SUBJECT: NuScale Power, LLC Response to NRC Request for Additional Information No. 9513 (eRAI No. 9513) on the NuScale Topical Report, "Non-Loss of Coolant Accident Analysis Methodology," TR-0516-49416, Revision 1

Response to Request for Additional Information Docket: PROJ0769

eRAI No.: 9513

NRC Question No.: 15.00.02-15

Figure 5-2 Measured vs predicted heat transfer coefficient

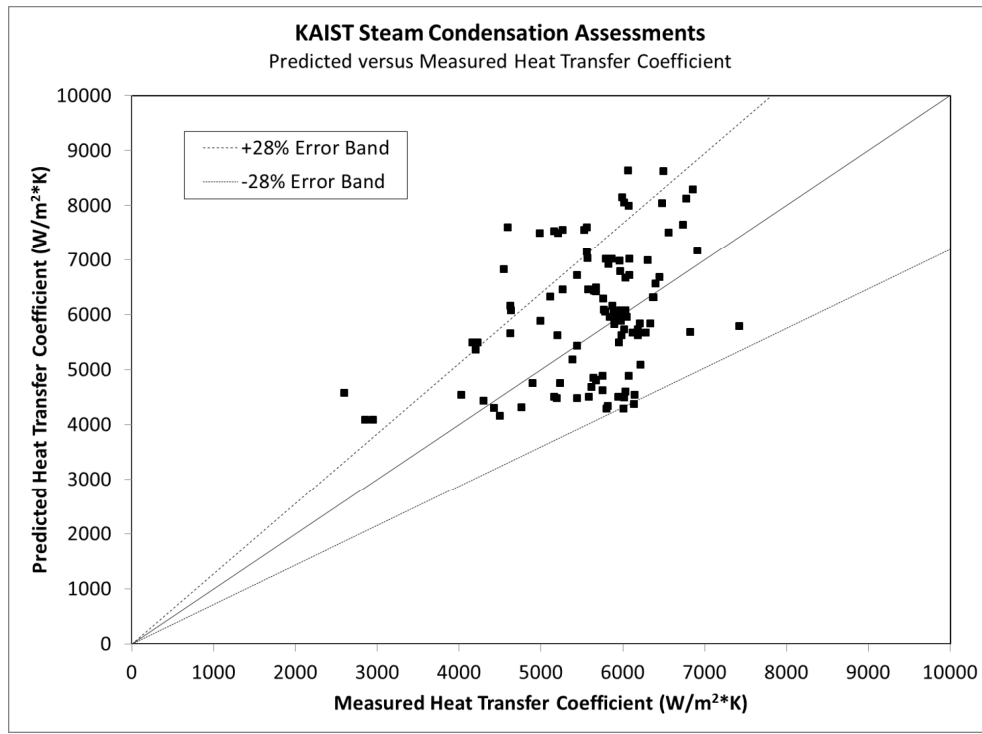
TR-0516-49416-P, Section 5.3.1, describes the KAIST experiments, which formed part of the validation of the NuScale NRELAP5 DHRS model. TR-0516-49416-P concludes that the assessment shows reasonable to excellent agreement between calculated NRELAP5 and KAIST measured data. While the staff observes the agreement is generally good, the staff is of the opinion that the assessed quantities (condensed liquid flows, heat transfer coefficients, and inner wall temperatures) do not provide adequate assurance of qualification of the NRELAP5 DHRS model to predict {{ }}^{2(a),(c)}, so additional information is therefore necessary to support a finding on GDC 10 and 15. Please provide additional justification of the qualification of the NRELAP5 DHRS model for this purpose, such as a plot of measured versus calculated total heat transfer as a function of pressure {{ }}^{2(a),(c)}. Update TR-0516-49416-P as appropriate.

Correction of the Measured Inner Wall Temperature Uncertainty Band

The inner wall measurement temperature uncertainty is {{ }}^{2(a),(c)} as determined by KAIST.
{{

}}^{2(a),(c)} Figure 5-2 of the KAIST assessment results in the non-LOCA topical report (TR-0516-49416-P) was revised to show the updated results as indicated at the end of this response.
